AGENDA
LANSDALE BOROUGH COUNCIL MEETING
WEDNESDAY JUNE 15, 2016
1 Vine Street, Lansdale
7:00PM

Re: WWTP Capacity Upgrade Change Order No. 5

Change Order No. 5

Work Change Directive No. 7

DATE	AUGUST 2014
NO. OF SHEETS	90145-001
CONTRACT NUMBER	
DRAWING NUMBER	E103

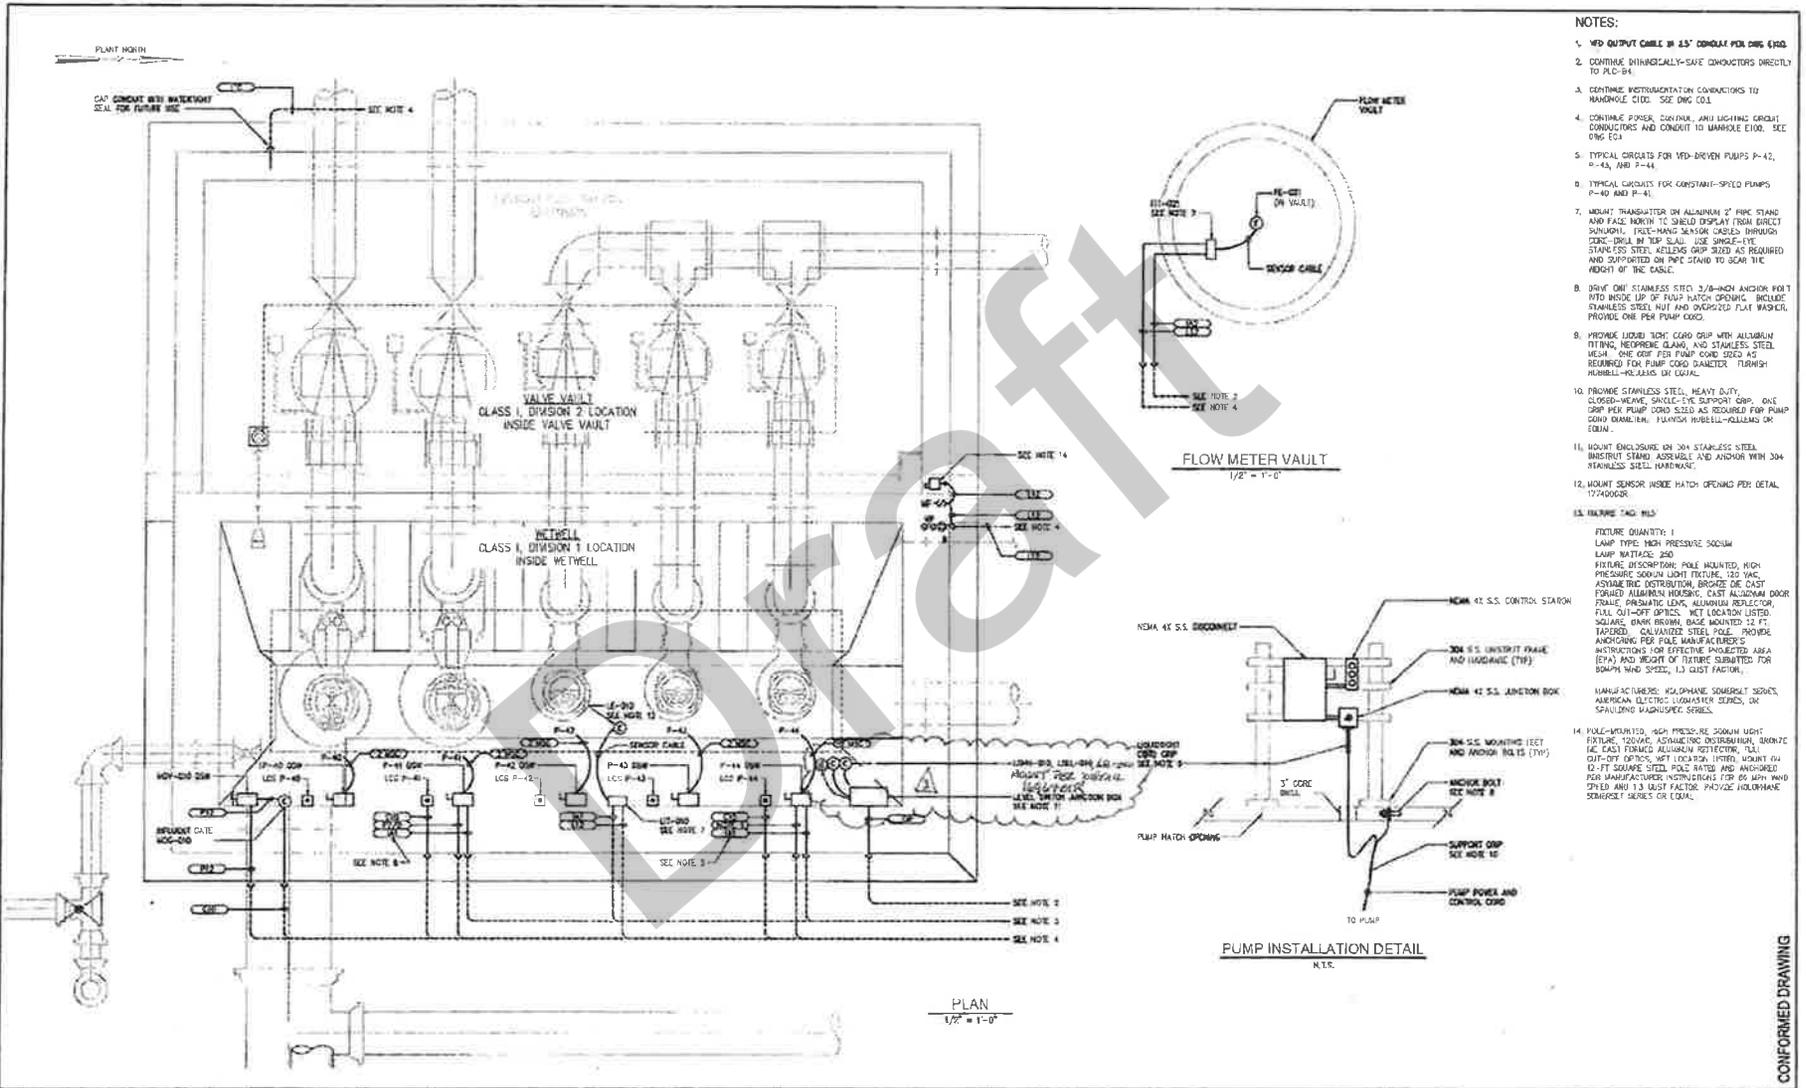
Provide one additional float switch, LSL-010, located in the Influent Pump Station Expansion wet well. Mount LSL-010 per detail 1696701R at 31" above the bottom of the wet well. Coordinate with Owner in the field to either pull a new conductor or utilize spare conductor for signal back to PLC-B4. Provide an additional intrinsically safe relay in PLC-B4 for LSL-010 and hardwired relays, as needed. Instead of shutting down all pumps with LSL-040, shut down Pumps P-40 and P-41 with new LSL-010, and shut down Pumps P-42, P-43, P-44 with LSL-040, which has already been lowered to 21" above the bottom of the wet well. Monitor LSL-010 with PLC-B4 at Rack 1, Slot 4, Point 11.

In addition, provide control system programming for flexibility of automatic operation for Pumps P-42, P-43, and P-44 to operate based on wet well level instead of flow (see attached modifications to Section 17950, Functional Control Descriptions).

- Drawing I100 – Process and Instrumentation Diagram Influent Pump Station Expansion
- Drawing E101 – Influent Pump Station Expansion Electrical Block Diagram and Panel Schedule
- Drawing E103 – Influent Pump Station Expansion Electrical Plan
- Modifications to Section 17950 – Functional Control Description for level-based operation of Pumps P-42, P-43, and P-44
